**Petition for Modification
Tanager Battery Energy Storage System Project**

Data Response Set 1A

**Los Esteros Critical Energy Facility
03-AFC-02C**

DATA RESPONSE SET 1A

Figure 1. Hithium BESS fire protection system including gas detectors

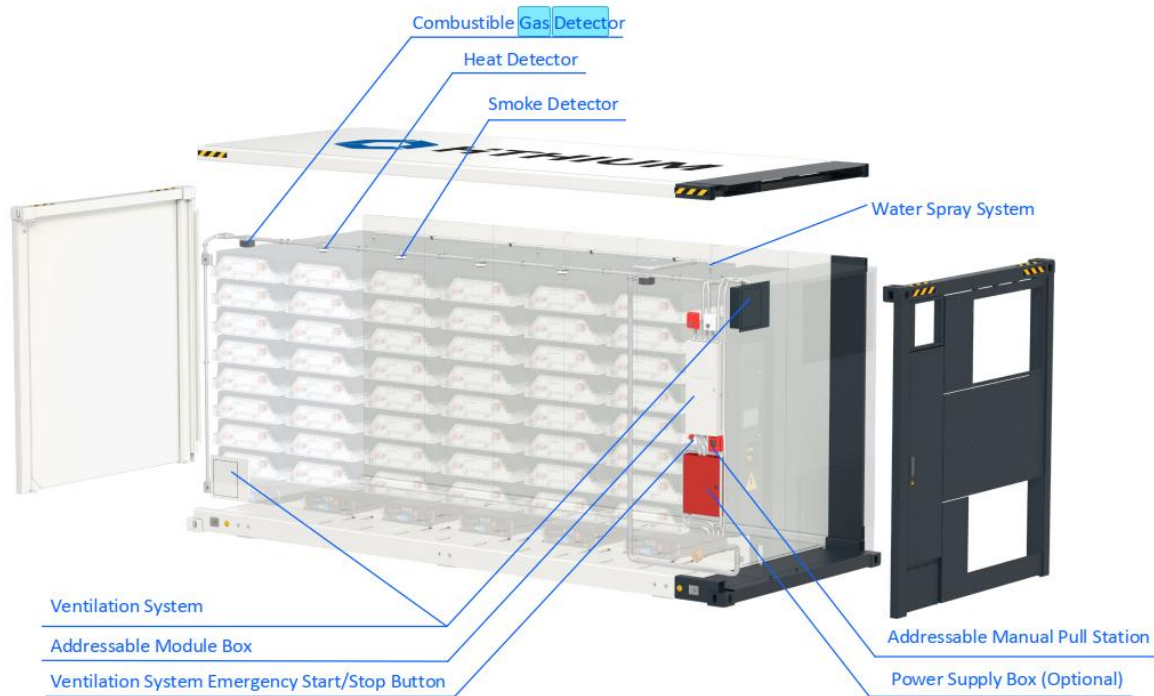
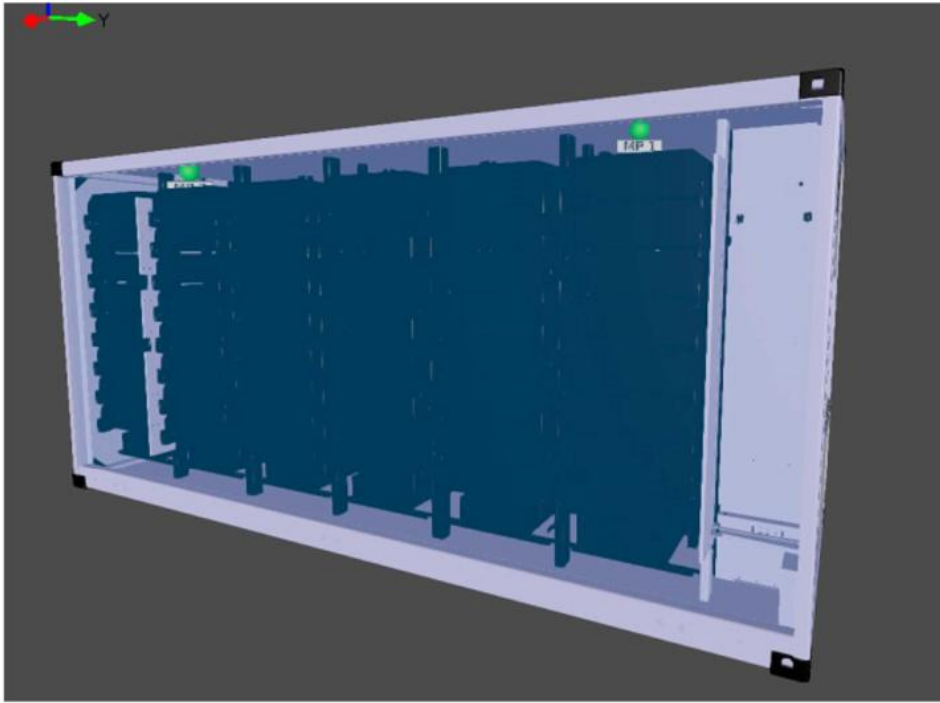
A21. Please provide a schematic of the proposed battery container gas detection systems and a detailed description of these systems.

Response: The BESS container is equipped with two (2) combustible gas detectors, calibrated to hydrogen (H₂) target gas. Explosion protection is provided

by an explosion prevention exhaust system that is activated upon 10% LFL combustible gas detection. Site fire alarm control panel(s) (FACP) will be installed at the first responder station at the BESS site for the monitoring and control of the fire alarm devices for the BESS. The FACP will be capable of announcing smoke, gas, and heat alarms along with the activation of the explosion control system.

The gas detectors shown on Figure 1 are located below the roof of the battery container to monitor the concentration of hydrogen and trigger safety measures. Safety measures could include activating ventilation, sounding alarms, and shutting down the BESS to prevent a fire or thermal runaway event. Figure 2 shows a view of the gas detectors from the front of the battery container.

Figure 2. Location of gas detectors, front view.

Figure 3. Hithium BESS Fire Protection System

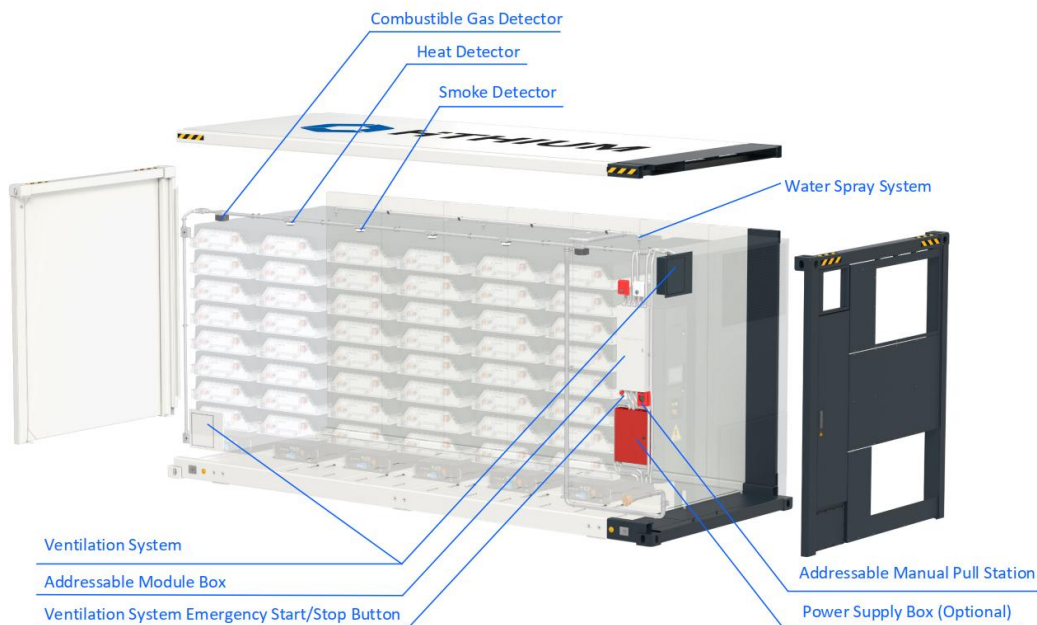
A32. Please provide a schematic of the proposed battery container fire suppression systems and a detailed description of these systems.

Response: The proposed BESS containers are non-occupiable enclosures, installed outdoors and do not require fire-extinguishing systems per CFC §1207.5.5. The

BESS integrates a fire protection (or prevention) system composed of heat detector, smoke detector, horn/strobe, addressable manual pull station, power supply box (optional), addressable module box, combustible gas detector, and ventilation system, as shown below. In addition, it includes safety features such as explosion control, battery management system (BMS), automatic fire detection and alarm, and electrical fault protection devices.
